RIVENWICK VILLAGE 4TH ADDITION

RAMSEY, MINNESOTA

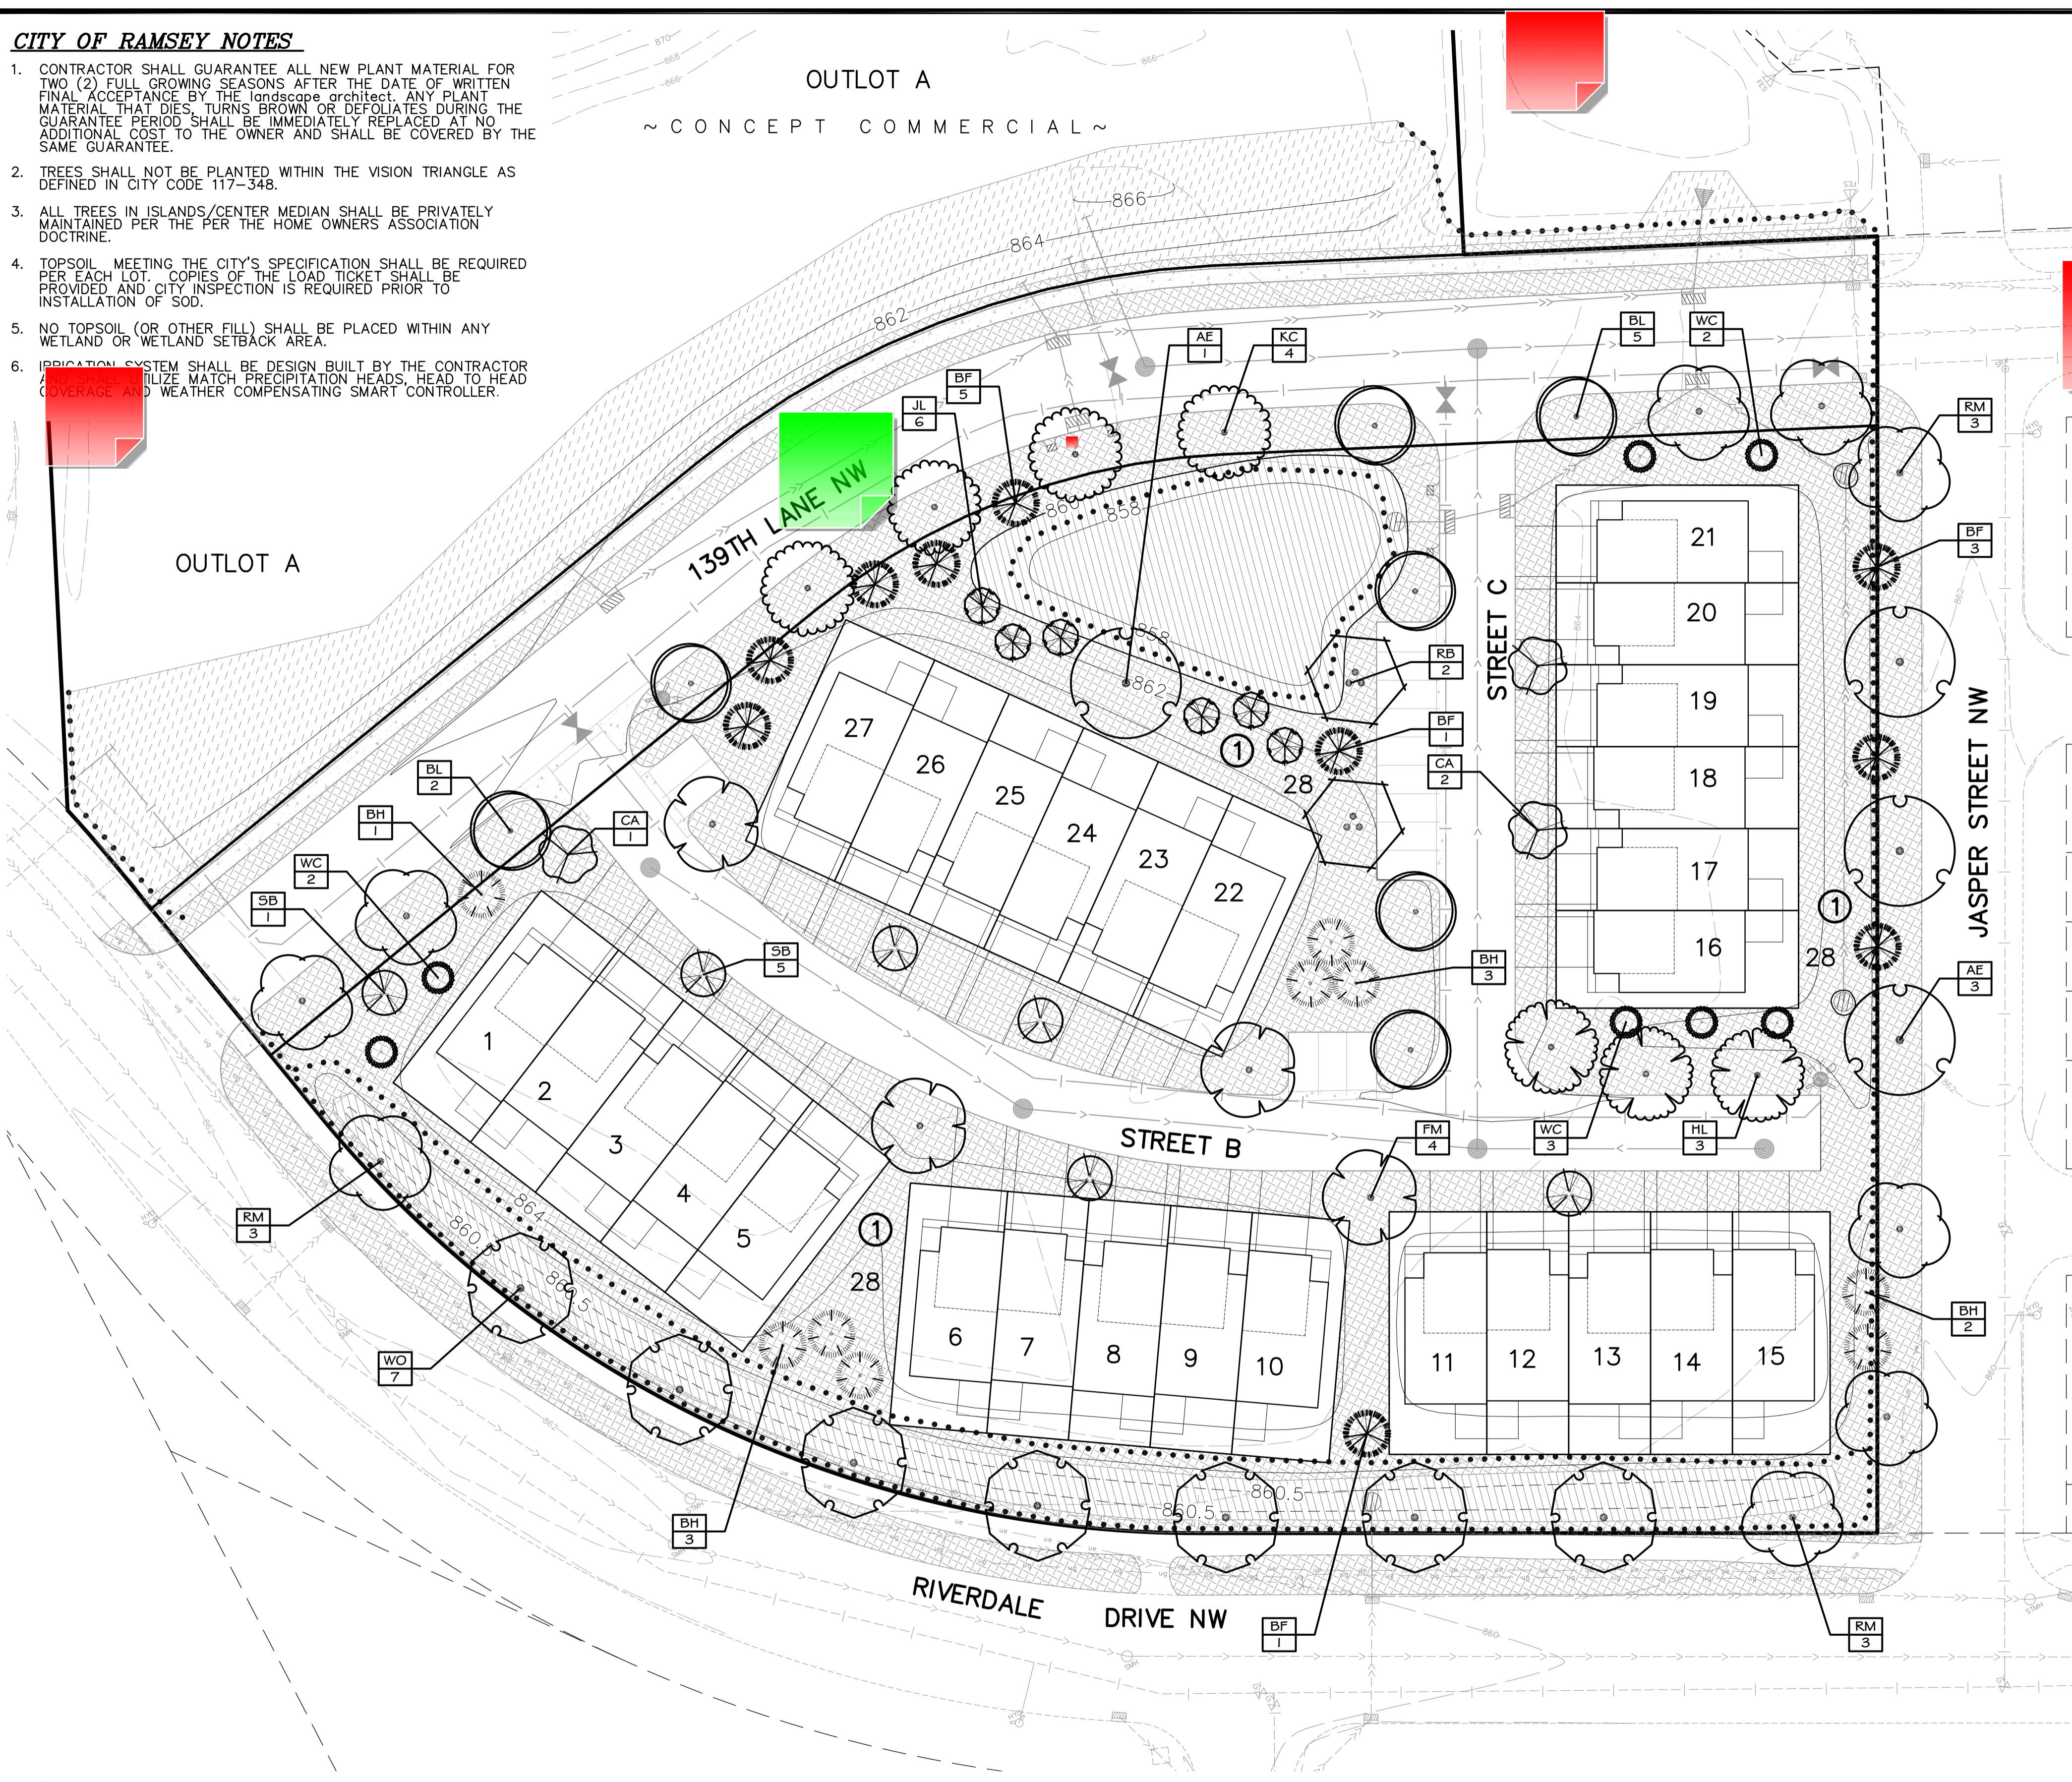
- EXISTING CONDITIONS.** CONTRACTOR SHALL VERIFY EXISTING CONDITIONS PRIOR TO BIDDING AND CONSTRUCTION START. ANY DISCREPANCIES FOUND THAT AFFECT THE WORK SHALL BE REPORTED TO THE OWNER/LANDSCAPE ARCHITECT FOR CLARIFICATION PRIOR TO BIDDING OR APPROVING ANY ADDITIONAL WORK REQUIRED.
